## Joyful View Subdivision Final Drainage Report

May 2023

PCD File No. SF2231

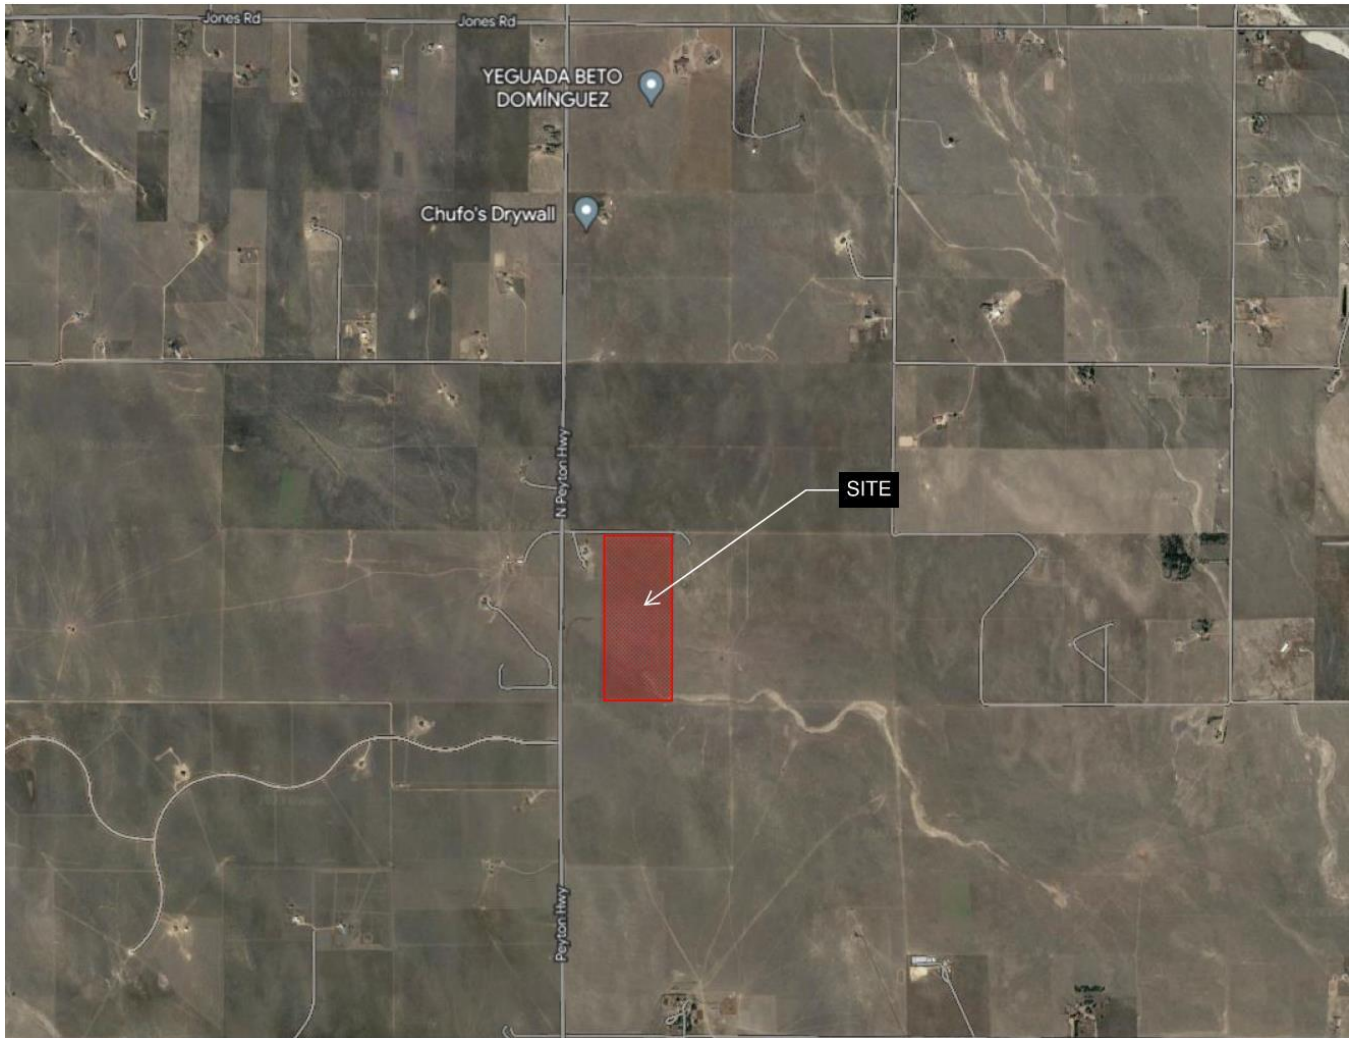
Include paragraph discussing channel. Need to provide analysis that no impacts are being done to the channel, velocity, depth, Fr #, etc are still within design parameters. Has a no-rise certification been submitted to floodplain manager?

# Culvert Report

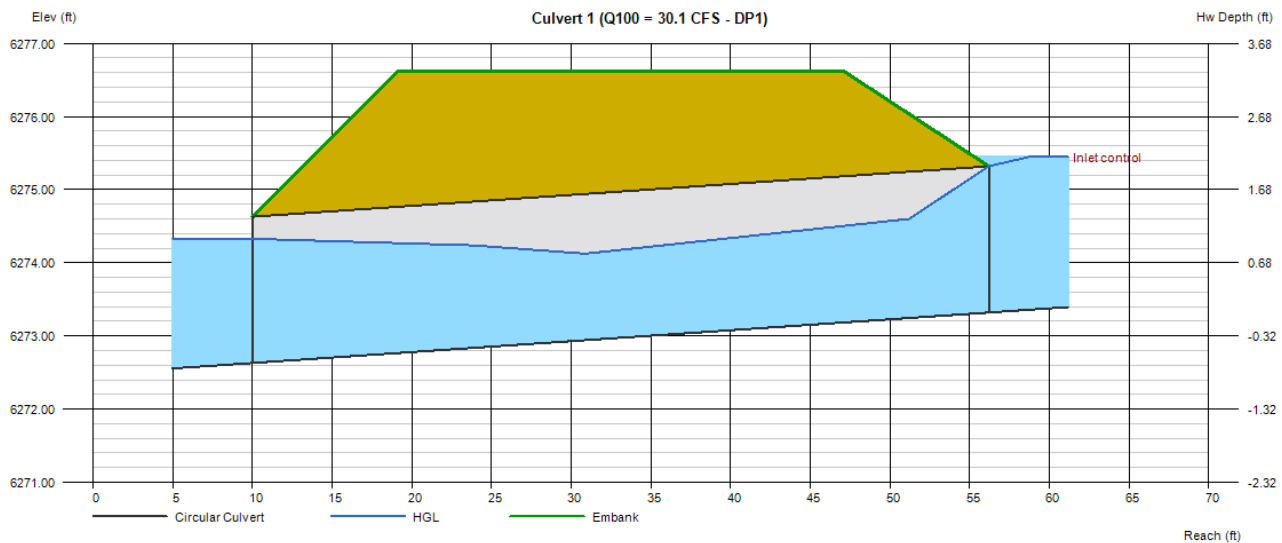
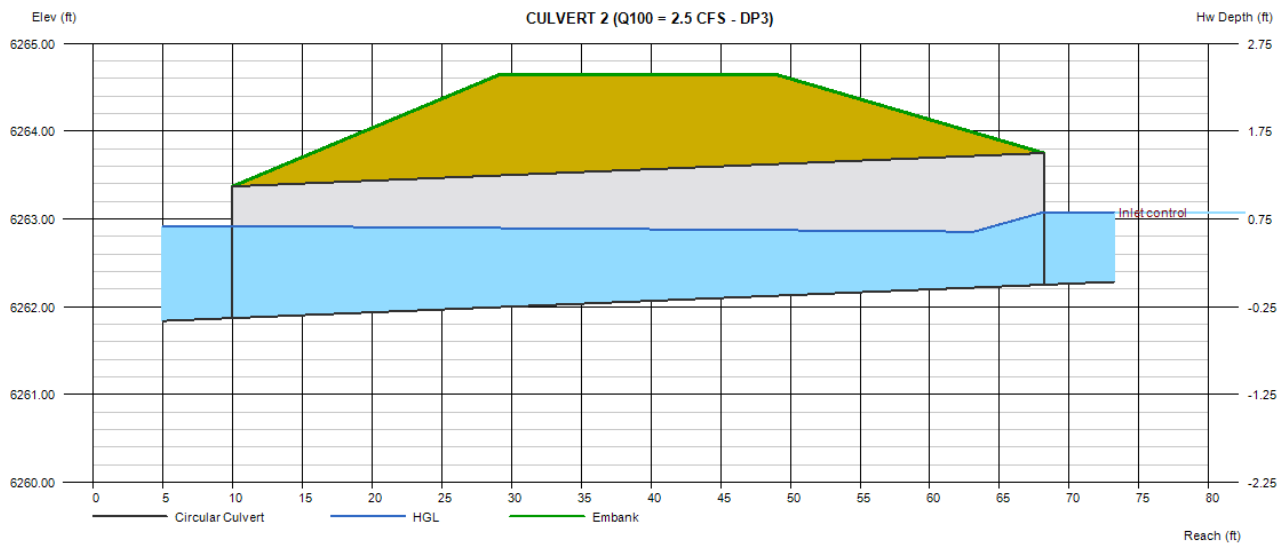
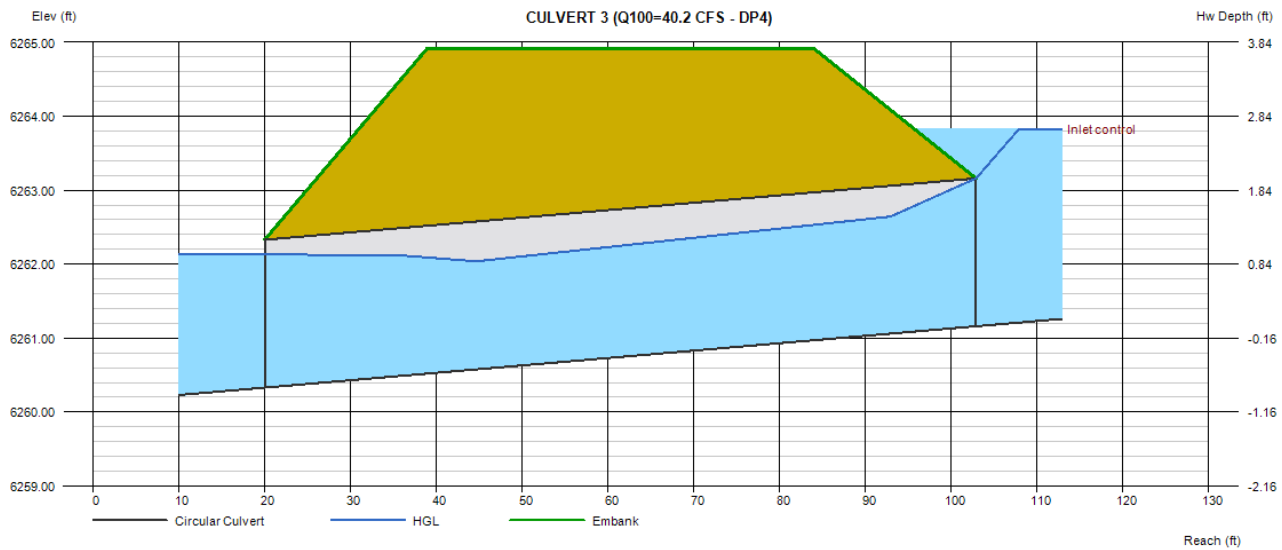
Provide calculations for outlet protection at culverts.

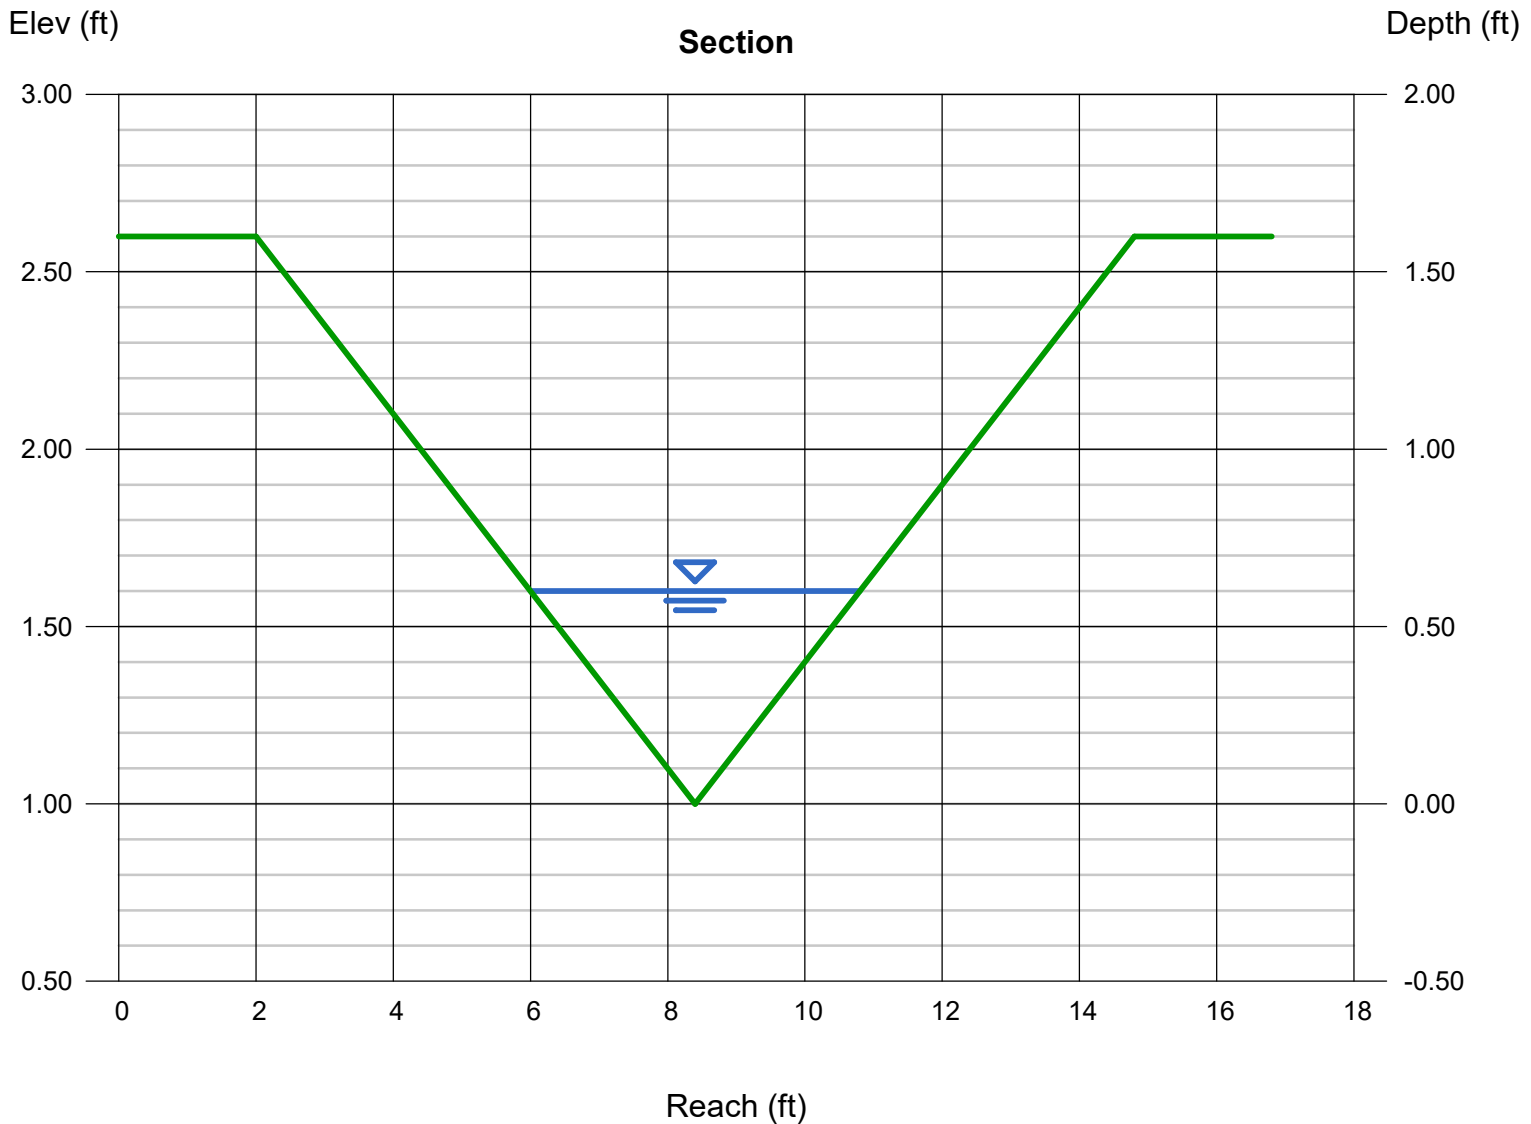
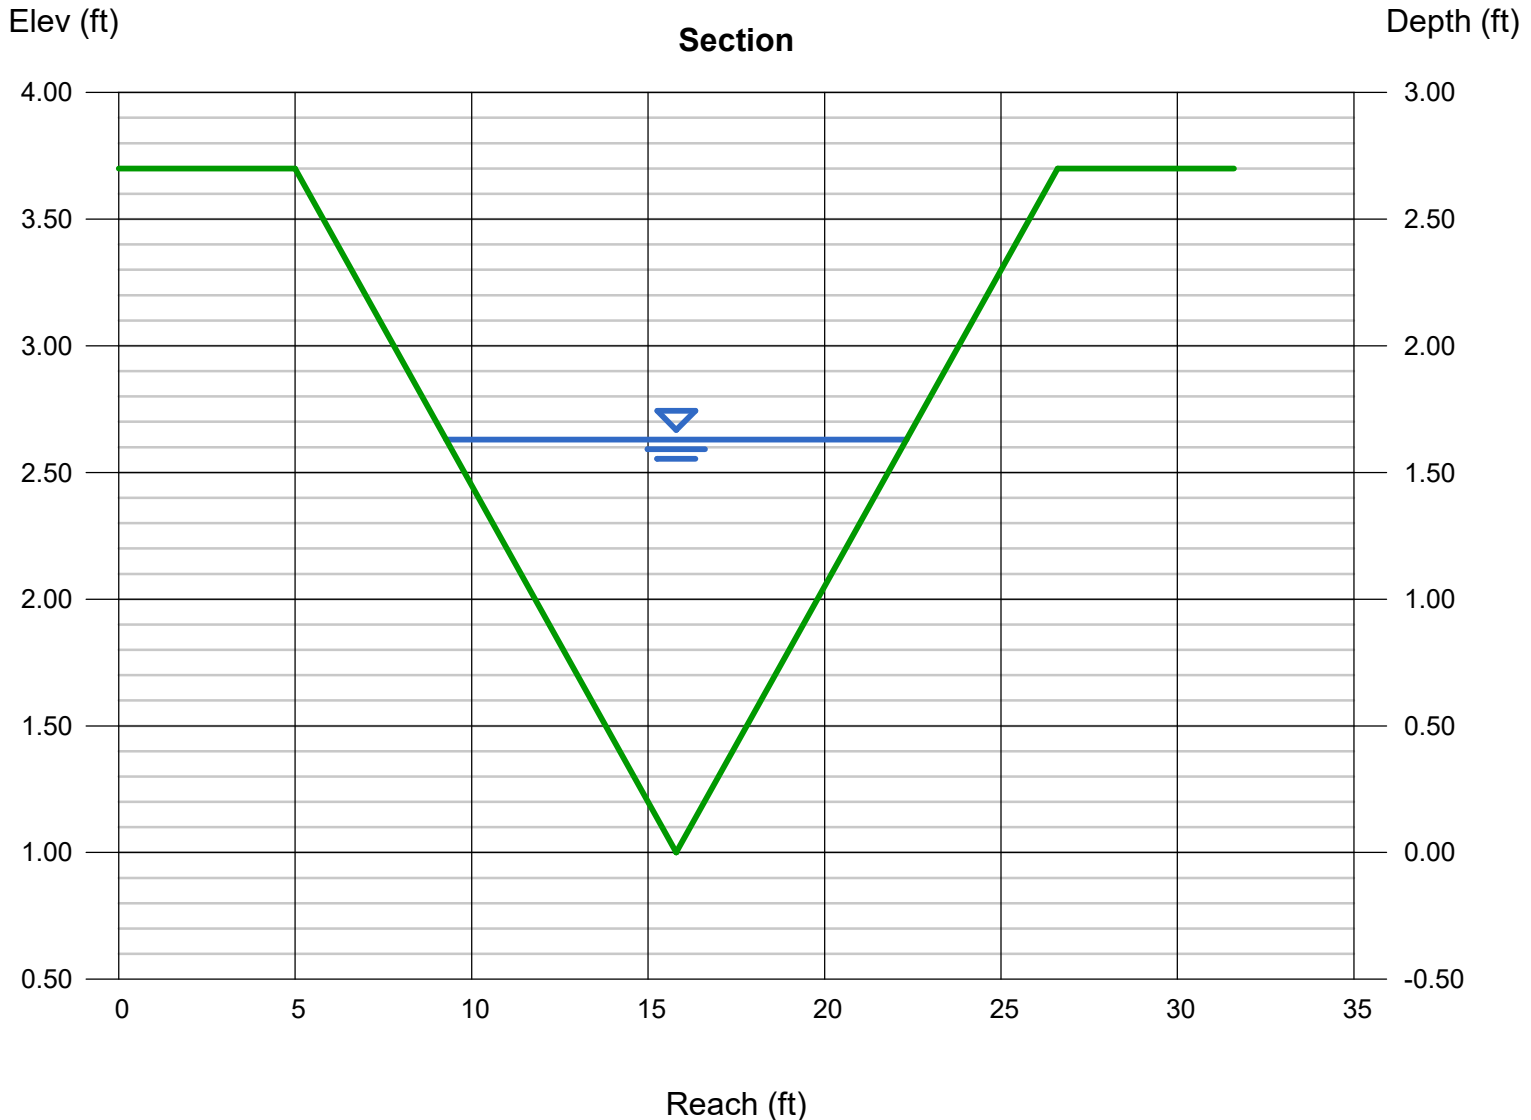
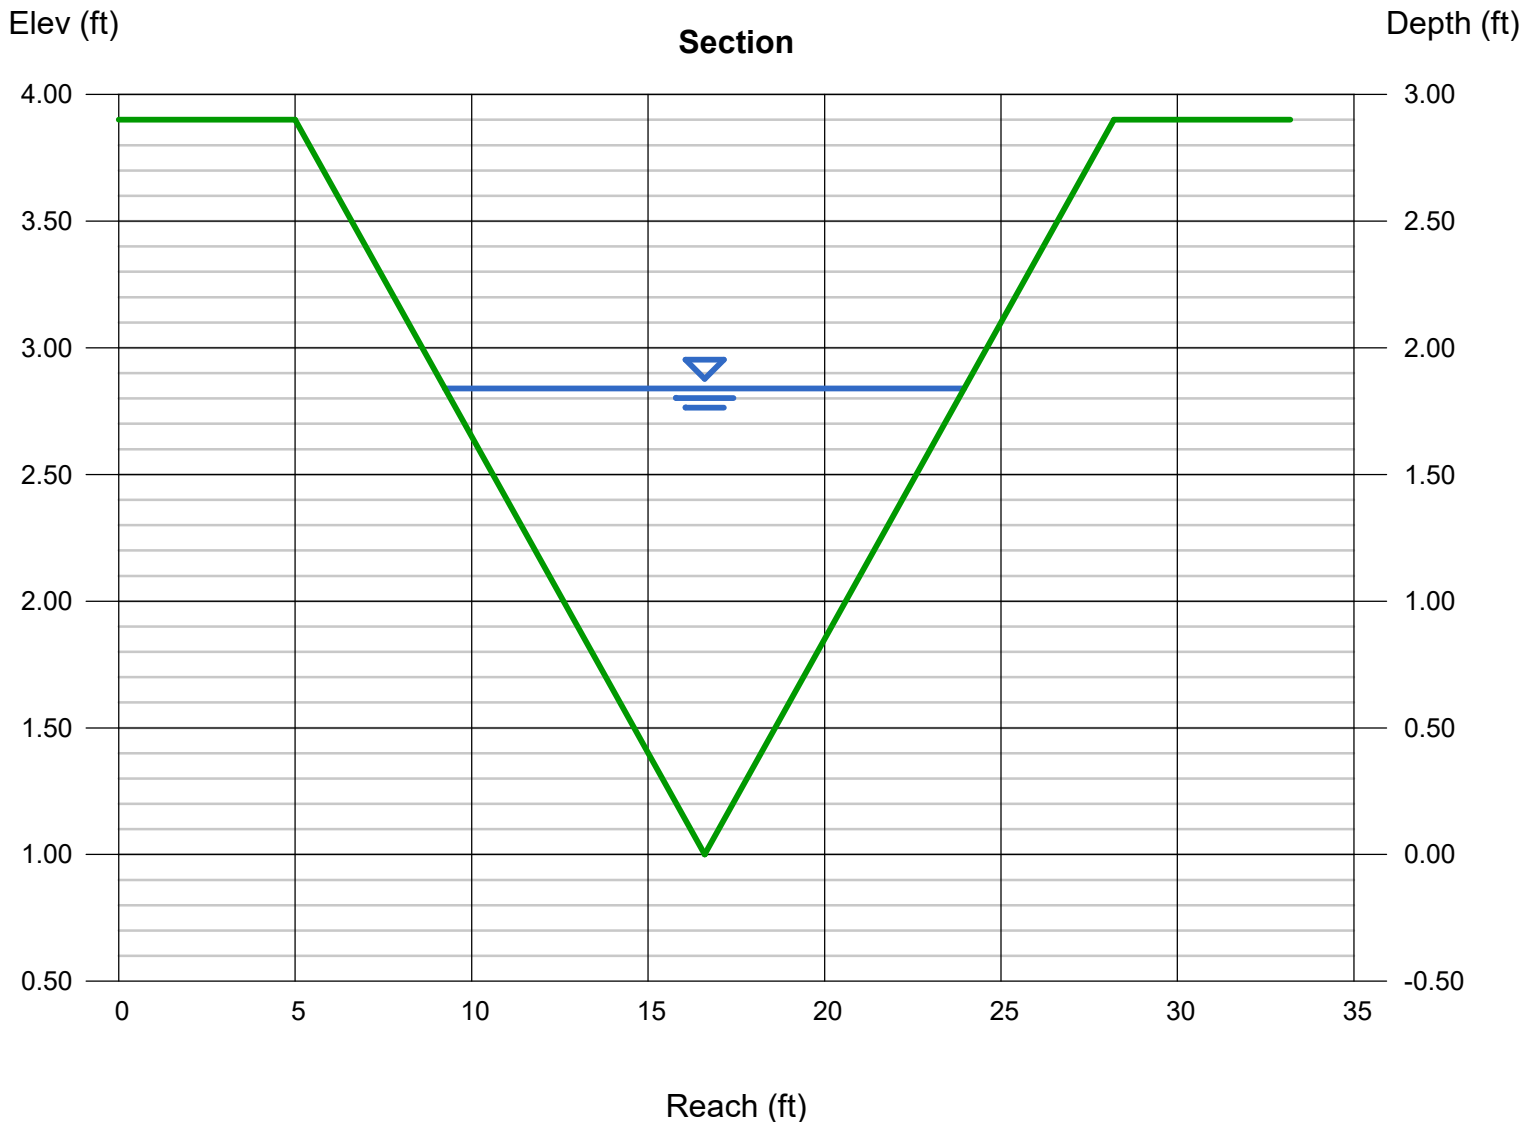
Provide analysis of major channel through site to ensure stability of channel (Velocity, flow depth, Fr #, etc)
